Agricultural and Forestry Sciences

UNIVERSIDAD DE LA FRONTERA

June 29, 2020

We change the title to “The mudflow disaster at Villa Santa Lucía in Chilean Patagonia: understandings and insights derived from numerical simulation and post event field surveys” as it was suggested by the third reviewer (see **Response to GCR3\_1**)

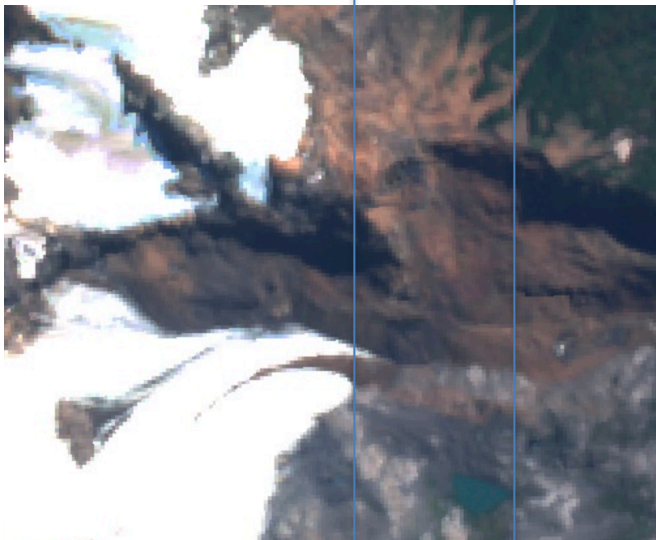
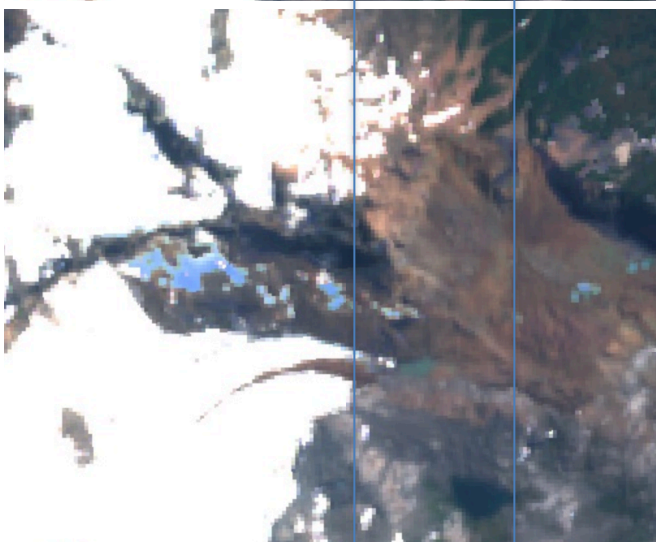
**SCR1\_9:** L157: I would expect a little bit more information on the landslide-glacier interaction. Was there some glacier ice entrained, which was included in the flow downstream? This can be an important issue, even though it is not always straightforward to analyze its importance (see e.g.: *Mergili, M., Jaboyedoff, M., Pullarello, J., Pudasaini, S.P. (2020): Back-calculation of the 2017 Piz Cengalo-Bondo landslide cascade with r.avaflow. Natural Hazards and Earth System Sciences 20: 505-520. doi:10.5194/nhess-20-505-2020*)

**Response to SCR1\_9:** Yes, this is an issue that we discuss, and as the reviewer mentioned, it is not a straightforward one. We did not quantify this, not have knowledge that somebody else did. However, we looked into satellite imagery to understand this interaction or to guess the importance of the ice entrainment. In the figure below, we put three images from the landslide area. The first image is an Aster image from 2010, the second is a Sentinel-2 image from 2017 before the event, and the third is a Sentinel-2 image after the event.

When we compare Figures a and b, we can see that the glacier terminal shrunk about 250 meters from 2010 to 2017, exposing the walls in the north side. However, when we compare Figures b and c, we can see that the landslide moved away from the glacier terminal. The shape of the glacier terminal was not modified. The only option that we have left is that the end of the glacier is covered by debris. This is plausible; however, the volume remains unknown. Also, there is no indication of a glacier lake, as it was indicated in earlier studies. We can not ignore the fact that there was glacier entrainment, there is clear evidence in the field that there was. However, given the little information related to the volume of ice involved in this process, we seek to demonstrate using numerical modeling that the water available in the river banks and valley downstream was enough or nearly enough to generate a mudflow. We are aware though that there were other sources of water involved

On December 16, 2017, a 7 million cubic meter volcanic rock slide detached (Figure 3, point 1), falling next to the Yelcho glacier toe that sits on an intrusive formation that has a drop of about 80 meters. The glacier shows a retreat during the last decade. Sernageomin (2018c) indicated that there might have been a small lake and water available on top of the intrusive formation, but there is no conclusive information. Satellite images before the events do not indicate a lake above the intrusive unit. Also, there were indications that ice contributed to the mudflow. *Remote sensing data do not show that the landslide fell on top of the glacier unless detritus had covered the glacier, although we can see ice on top of the flank that collapsed. However, we do not have data to prove or disregard the covered ice on the intrusive and how much water it contributed to the mix.* Two million cubic meters of the material stayed above the intrusive, and five million cubic meters of material continued downstream, sliding on the intrusive unit at a slope of more than 70 degrees. At this point, the mudflow reaches the Burrito River with high topographic differences. The flow continued along with the drainage network at high speed (Figure 1 and Figure 3, point 2), adding a significant amount of sediment into the mudflow. The sediments are mainly associated with glaciolacustrine deposits (easy to mobilize) and ancient alluvials present in the valley and on the river walls.”

We modify Table 4, so now it look like this.

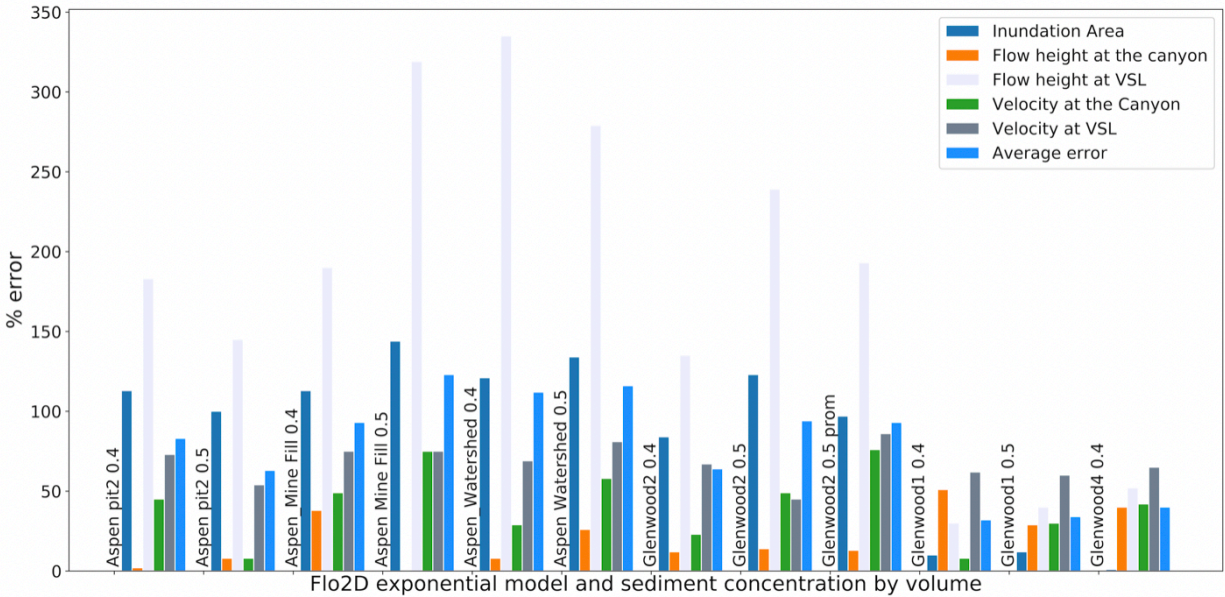
**SCR1\_17:** Further, there is no information about entrainment. Did you allow entrainment and, if yes, which value did you set for the entrainment coefficient? The “environmental resistance coefficient” is the “ambient drag coefficient”, I think. Further, the Quasi Reynolds number and mobility number are  $10^{4.5}$  and  $10^3$ . It is the logarithms which are given in the r.avaflow input.

Yes, we did use entrainment and the entrainment coefficient is  $10^{-5.75}$ , the mobility number are indeed  $10^{4.5}$  and  $10^3$ . Our mistake was that we translated entrainment to Spanish and then back to English as “drag”. We corrected this in the document as well as the symbol and the base 10.

Figure 8: R.avaflow modeling results for a concentration by volume of 50% (Background © ESRI).

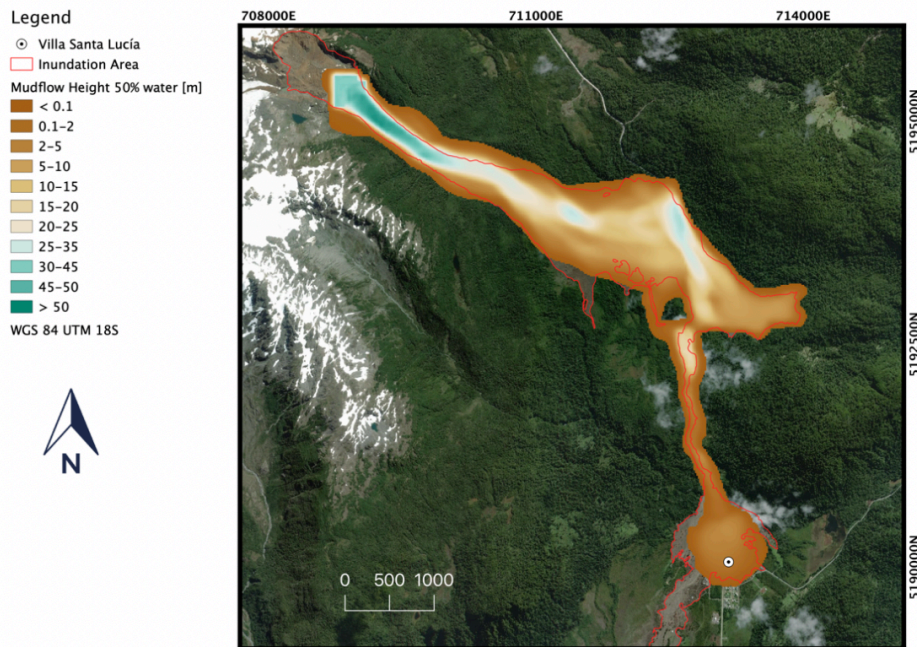
**SCR1\_18:** Fig. 12 (and some other places): flow high -> flow height

**SCR1\_20:** Fig. 14, legend: revise the thresholds: e.g., to which class would a flow height of 49.95 m belong?

**Response to SCR1\_18:** We replaced Figures 12-16, now they are Figures 8-12, see also **Response to SCR1\_20**.

We modified Figure12 (now figure 8):

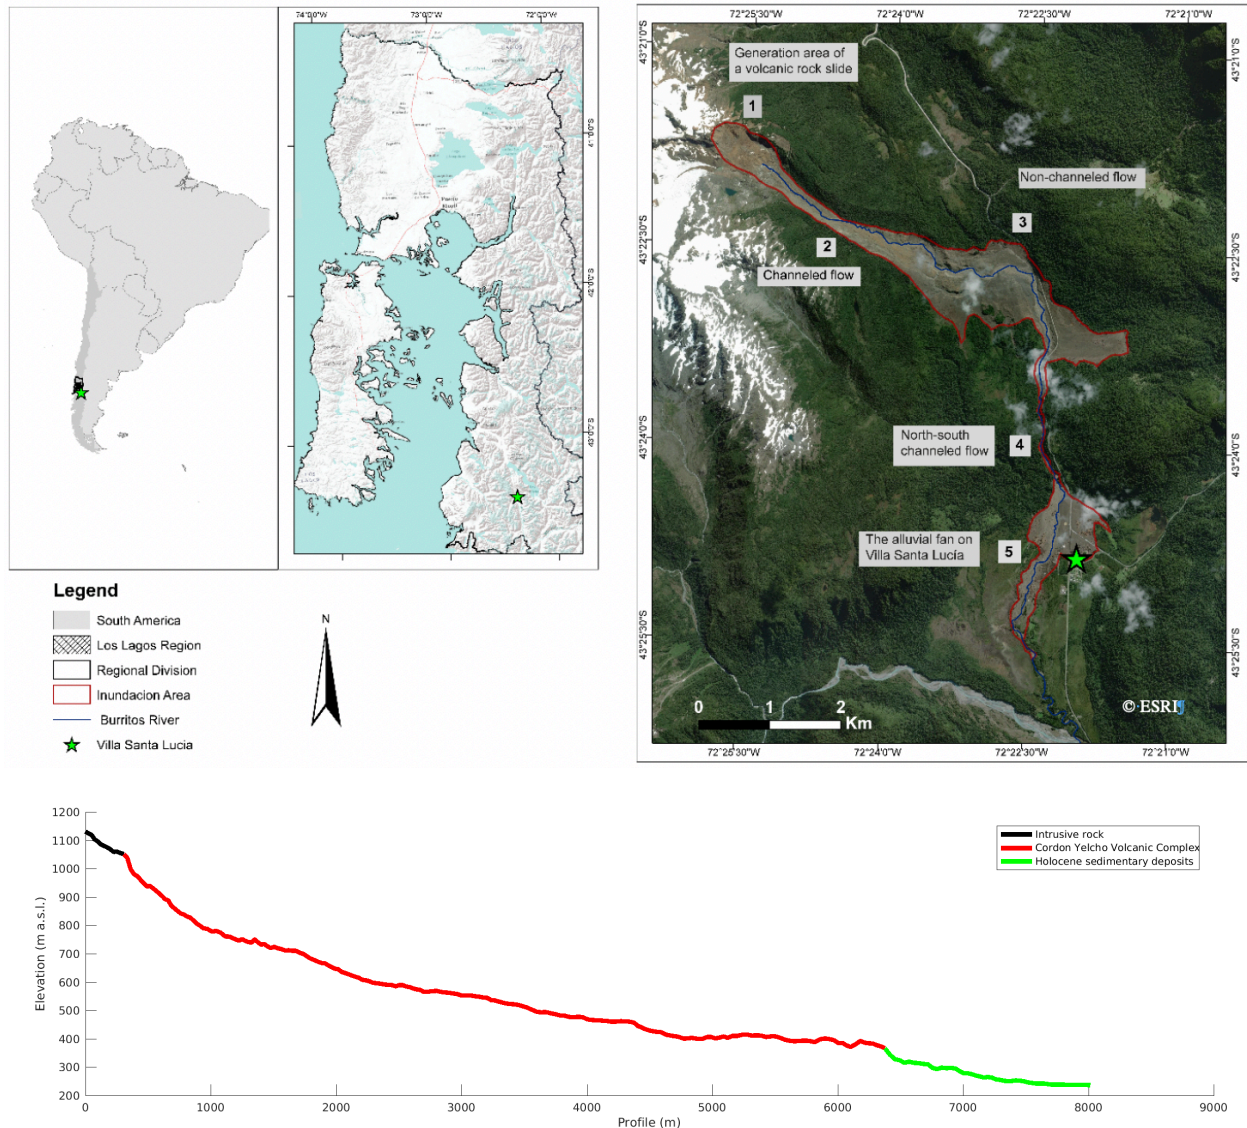
**CR2\_2:** Pages 7 to 10: Slope of land along the flow trajectory is one of the important factors for the mechanism of the landslide and debris flow. The more detailed information of the slope is needed. Therefore, the cross-sectional profile of the land along the flow is helpful for the discussion. Using the figure of the cross-sectional profile, the authors should discuss the landslide and debris flow event.

We added a slope profile in Figure 1, which now looks as follows

Figure: Curves used by Sernageomin (2018) to estimate the velocity of the flow in that section of the Burritos River.

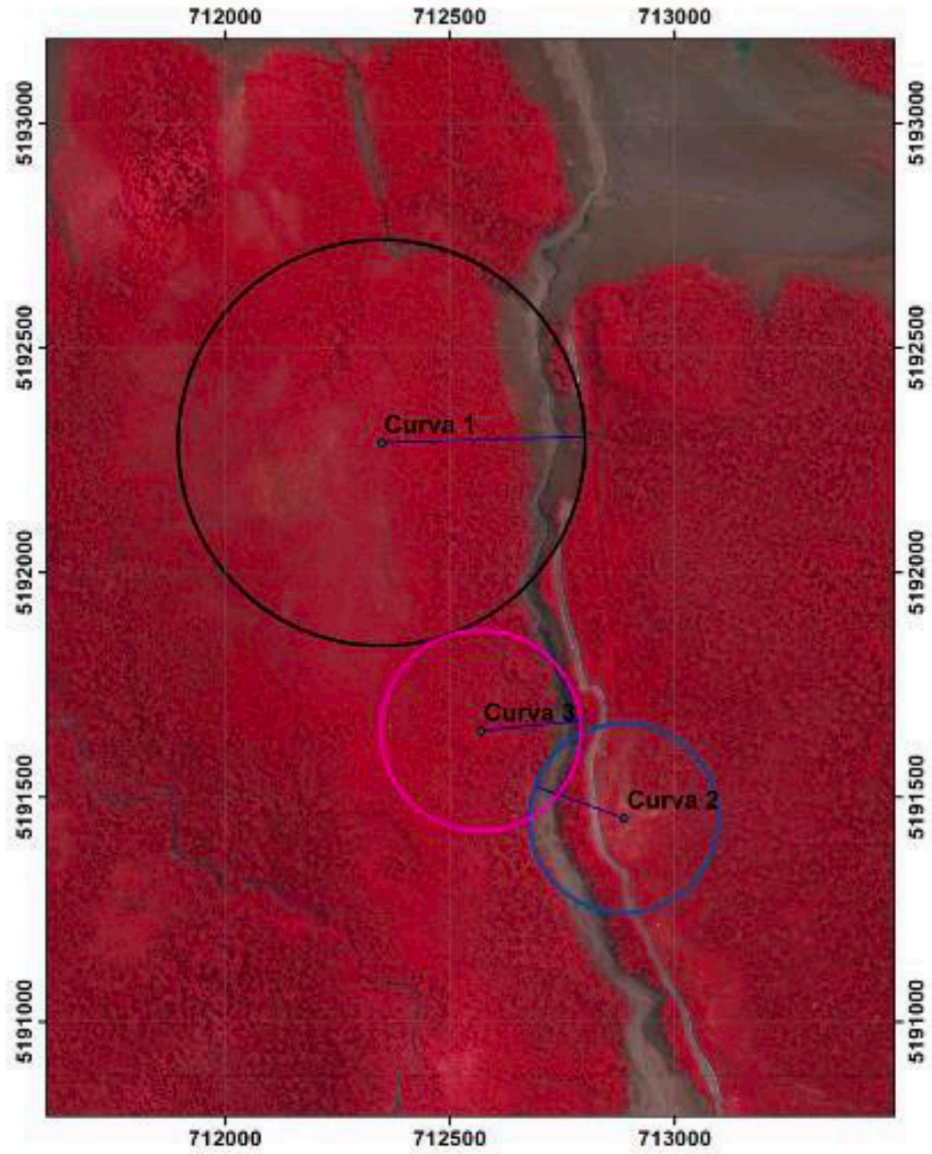
**CR2\_4:** Line 217, Page 10 Sernageomin (2018 c) found flow velocity 20 m/s at the Burritos River canyon. The authors should explain the method of estimating the velocity.

Sernageomin (2018) used Equation 1 from Johnson (1970) that empirically estimated the flow's velocity in a curve.

Since we did not do these calculations, we consider that we should not include them in our document and just cited the reference unless the editor thinks we should do so.

Figure 2: Geology of the study area (Modified from Sernageomin (1995))

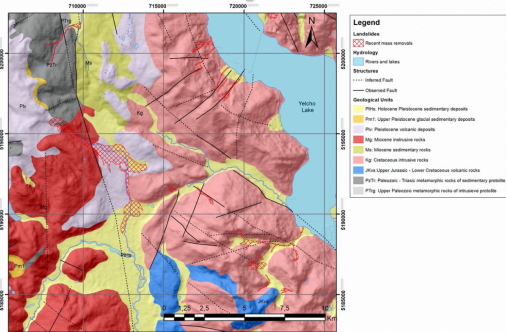
**SCR1\_6:** Figure 2: Nice figure, but there are some hispanicisms in the legend ... “Leyend” -> “legend”; “Hidrología” -> “Hydrology”; further, in the map itself the lake polygon should be deselected before exporting the map.

**Response to SCR1\_6:** We fixed the figure

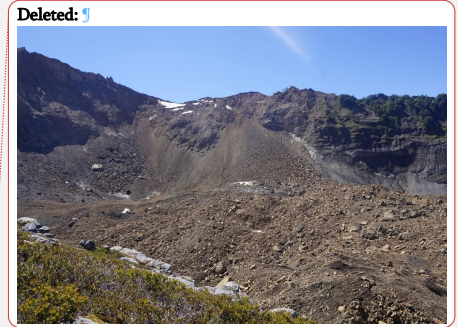
**SCR1\_11:** Figs. 4-8: They are very informative, but I recommend to put them together into one full-page figure with 7 panes or so.

**Response to SCR1\_11:** We put them all together in Figure 4

Figure 9: Error obtained with different water content and the best set of parameters obtained in the first calibration.

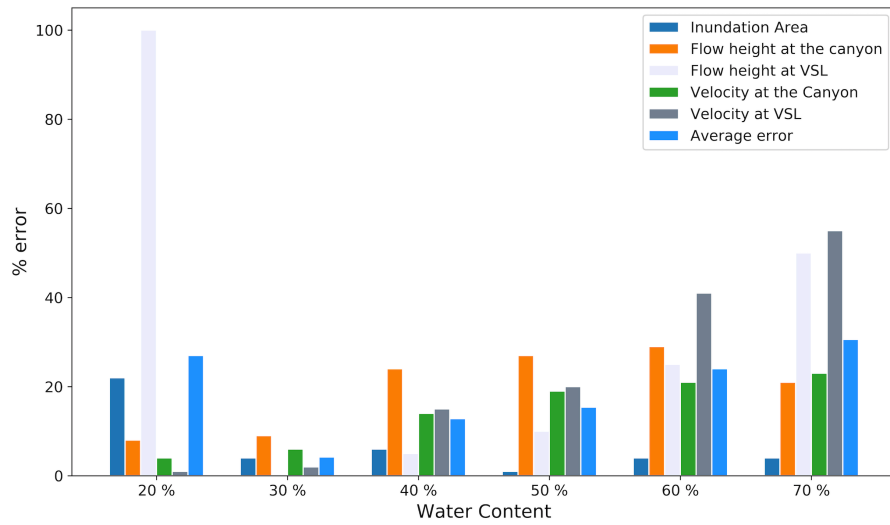
**CR2\_3:** Pages 10 and 19 The budget of sediment and water during this event is important for understanding the process of the landslide and debris flow. A schematic figure of this budget is helpful for the discussion.

**Response to CR2\_3:** We appreciate your observation. After reviewing in detail our manuscript, we noted that figure 13 needs to be explained correctly. Now, we inserted the following sentence in the results section of r.avaflow

“We varied the percentage of water between 20% and 70%. The error for the heights, speeds calculated in each model are in Figure 9. Therefore, we propose that a mudflow with a 30% water volume could reproduce best the VSL event (Figure 10).”

We renumber Figure 13 as Figure 9, according to the figure prioritization suggested by reviewers.
